DEVELOPMENT REVIEW BOARD sketch plan hearing scheduled for May 22, 2024 @ 7:00 pm

Applicants:	Never a Cloud Living Trust/Johns and Giovanna Congdon Consultant: Stephen Diglio, KAS Environmental Science and Engineering
Application No.: DRB 24-059-SK	Parcel ID: 00021-0640
Status of Applicant:	Owner
Requested Action:	Sketch Plan for Subdivision
Purpose:	Classify Subdivision
Zoning:	Rural District
Location:	653 Bingham Brook Road
Size:	23.15 acres
Existing Land Use:	Single-family residential
Surrounding Land Uses:	Residential and agriculture (Powden and Hausman farms)
Permitting / Subdivision History:	August 28, 1984: Planning Commission approval of three-lot subdivision (Lot #3 contained 56.1 +/- acre (C. Hinsdale III)) WW-138-1308 (water and wastewater - three-bedroom single-family residence) 13-26-TM: Three-bedroom single-family residence with detached garage and workshop PC-21-06-SA: subdivision amendment established current size of Congdon lot (23.15 acres), dedicated 58.79 acres to conservation (which included lands of the subject parcel), and increased the size of a lot containing an existing residence and maple operation at 3768 Spear Street. July 2022: change of address from

Results of the FEA wetlands delineation. See p. 17 of the application for a full-size rendering.

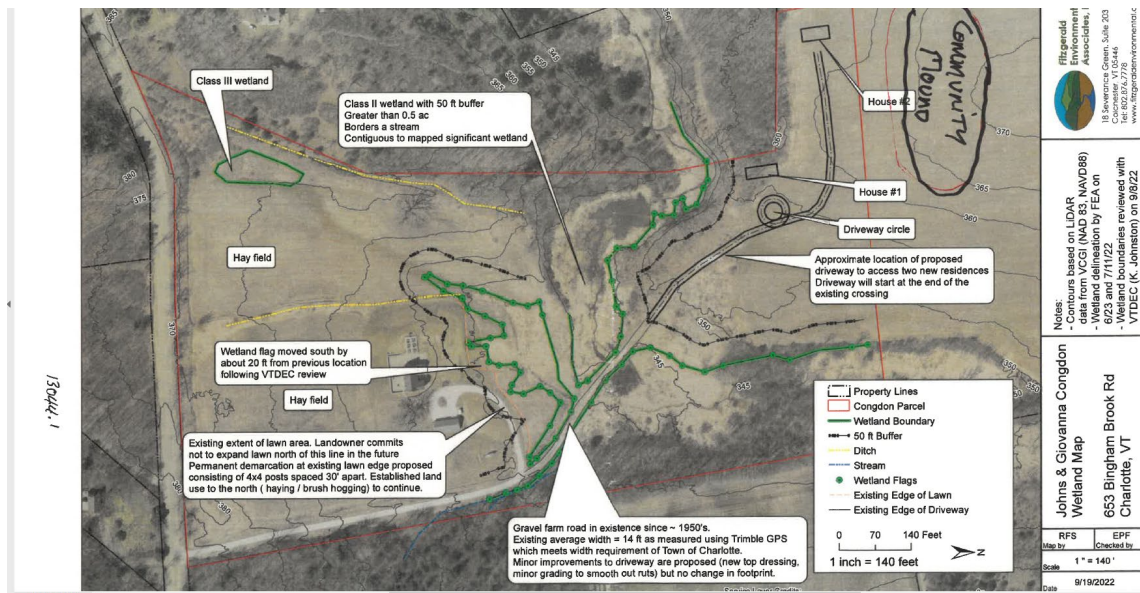
- c. Steep slopes (>=15%) – the Charlotte Map Viewer and ANR Atlas do not show any steep slopes.
- e. Surface waters, wetlands and associated setback and buffer areas – The application incorporates a wetlands delineation completed by Fitzgerald Environmental Associates and confirmed by the Vermont Department of Environmental Conservation in 2022. The existing driveway extends slightly into the wetlands buffer. The proposed building envelopes avoid development in wetlands, and the applicants also state that they intend to continue not mowing in sensitive areas.

Section 7.2 (E): Building Envelope: Building envelopes have been proposed for each lot. Lot 1 has a previously approved building envelope of 4.1 acres. The wetlands delineation (p. 17 of the application) and proposed plat (p. 18) appear to show different building envelopes, with the plat showing a substantially larger size for each lot. Proposed Lot 2 has an irregularly shaped building envelope that follows site contours. Lot 3 has a rectangular building envelope. The building envelopes for Lots 2 and 3 comply with district setback requirements and limit development to 4.03% and 3.43% of the total lot (p. 17), which complies with lot and building coverage limits. The Board should clarify whether the areas marked in the wetlands delineation are indeed the proposed building envelopes. That document – not the proposed plat – spells out the size and coverage maximums of the building envelopes.

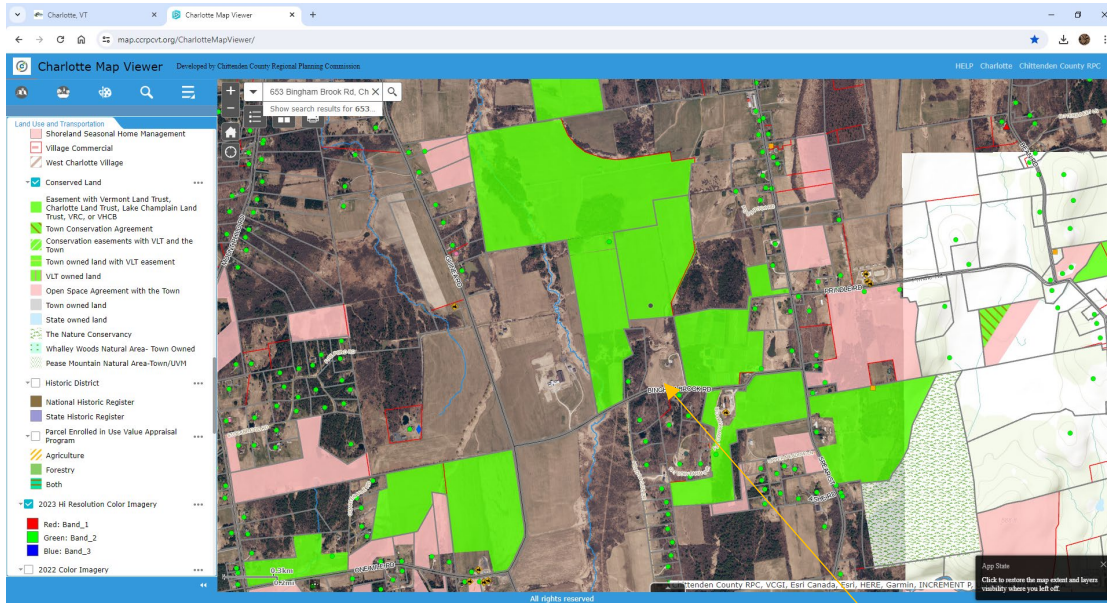
The subject lot is bordered by conserved land to the north and east.
